Docket Item # 5 & 6  
BAR CASE #2011-0364 & 0365

BAR Meeting  
January 18, 2012

**ISSUE:** Partial Demolition/Encapsulation and Alterations

**LOCATION:** 815 ½ King St

**Figure 1. Existing front (south) elevation.**

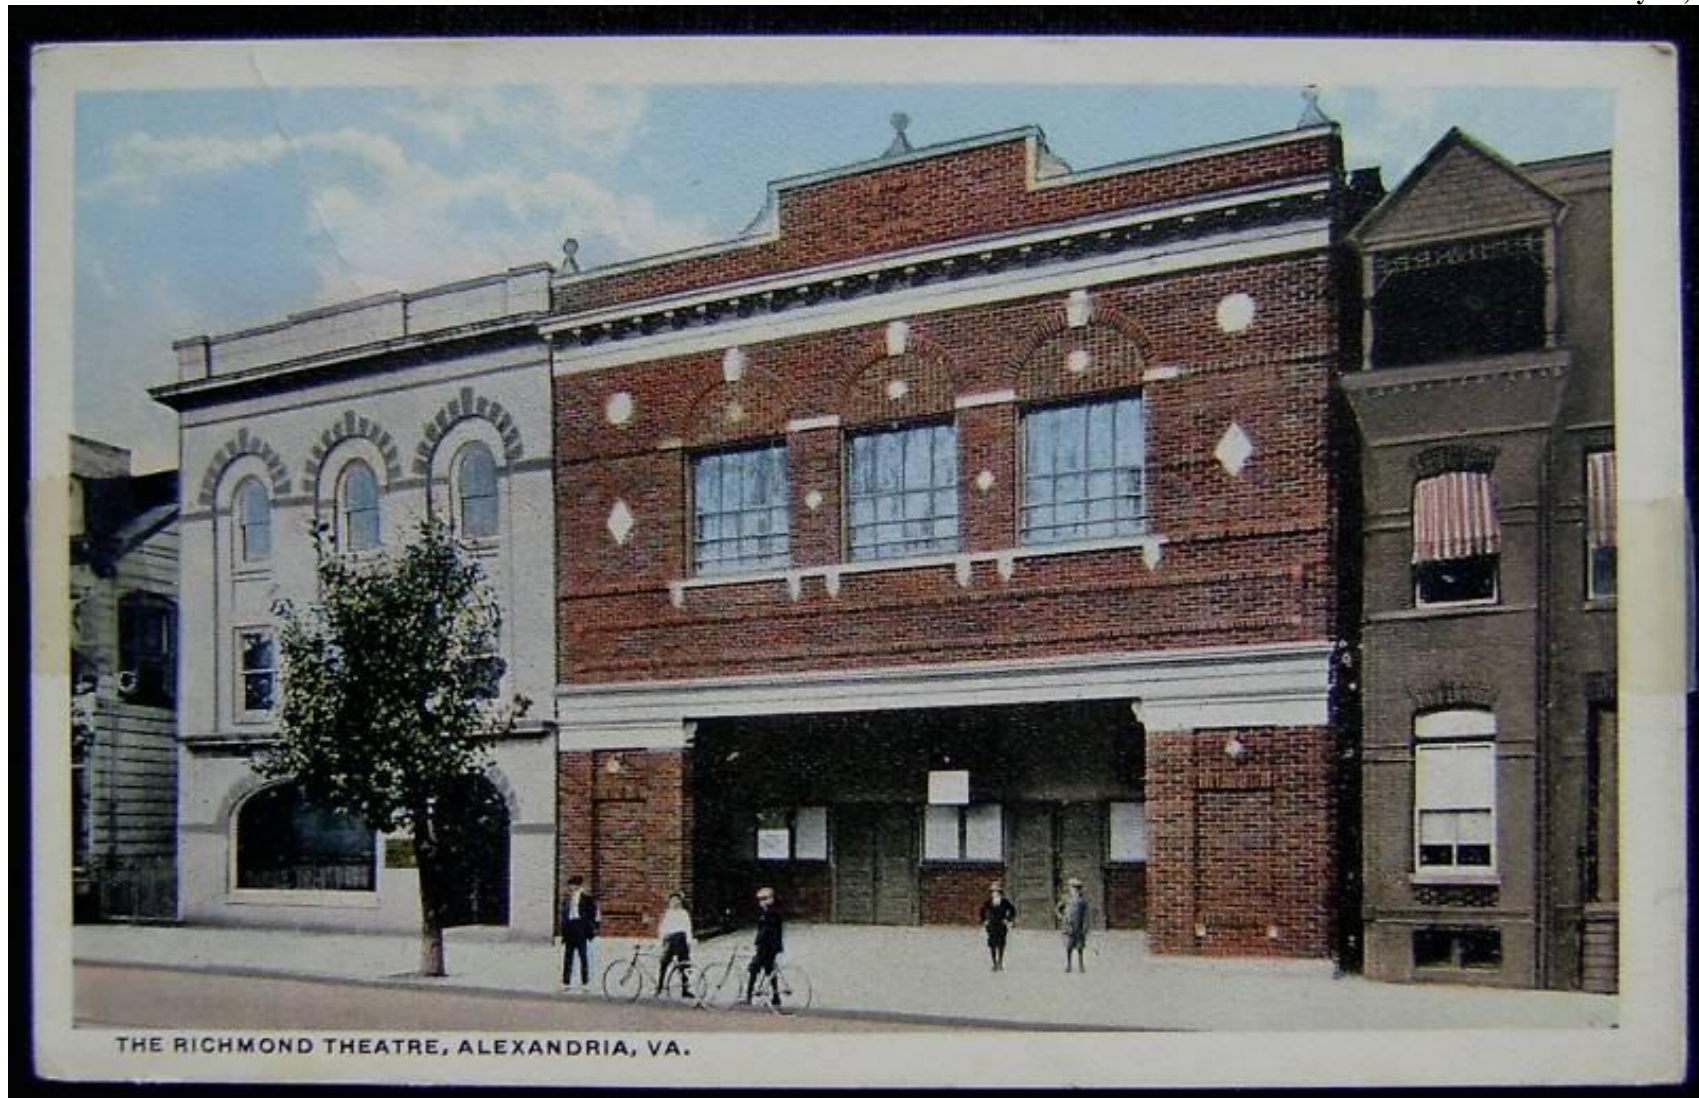
Staff finds that the existing modern marquee is out of scale and detracts from the historic architectural style and original character defining features of this building. The existing storefront system with pairs of double doors and a box office, as well as the display areas with terrazzo tile, are a more recent alteration with no historic significance and therefore Staff has no objection to removal of the existing marquee or first-floor storefront but recommends that the

It is evident that the original storefront metal cornice remains behind the marquee. As shown in the proposed alterations, this will be retained and repaired. This cornice is visually supported by the large restored brick piers on either side of the storefront and will become the dominant stylistic feature at the sidewalk level.
